TECHNICAL INFORMATION

74718

Subject ▶ Change of Spiral Bevel Gear 12 and Spiral Bevel Gear 50

For Models ▶ 9060DBL, 9060L, 9067DBL, 9067L, 9617L, 9069, 9069S

▶ Current	▶ New
 <p>Spiral bevel gear 12 (226772-1)</p> <p>Spiral bevel gear 50 (226771-3)</p> <p>Spiral bevel gear set (183908-4)</p>	 <p>Spiral bevel gear 12 (227500-7)</p> <p>Spiral bevel gear 50 (227499-6)</p> <p>Spiral bevel gear set (188092-0)</p> <p>Groove for distinction from the current</p>

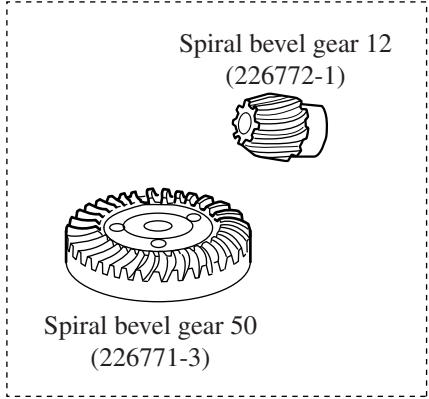
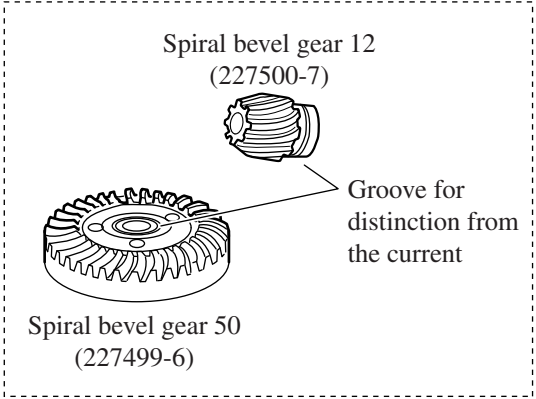
Description ▶ Spiral bevel gear 12 and Spiral bevel gear 50 have been changed as illustrated below.

Item No.	Current part		Q'ty	I/C	New part		Q'ty	Note
9060L, 9060DBL, 9067L, 9069, 9069S, : 006 9617L: 020 9067DBL: ---	Spiral Bevel Gear 12 226772-1		1	No	Spiral Bevel Gear 12 227500-7		1	Interchangeable as a set
9067L, 9069, 9069S: 039 9060DBL, 9060L: 035 9617L: 008 9067DBL: ---	Spiral Bevel Gear 50 226771-3		1	No	Spiral Bevel Gear 50 227499-6		1
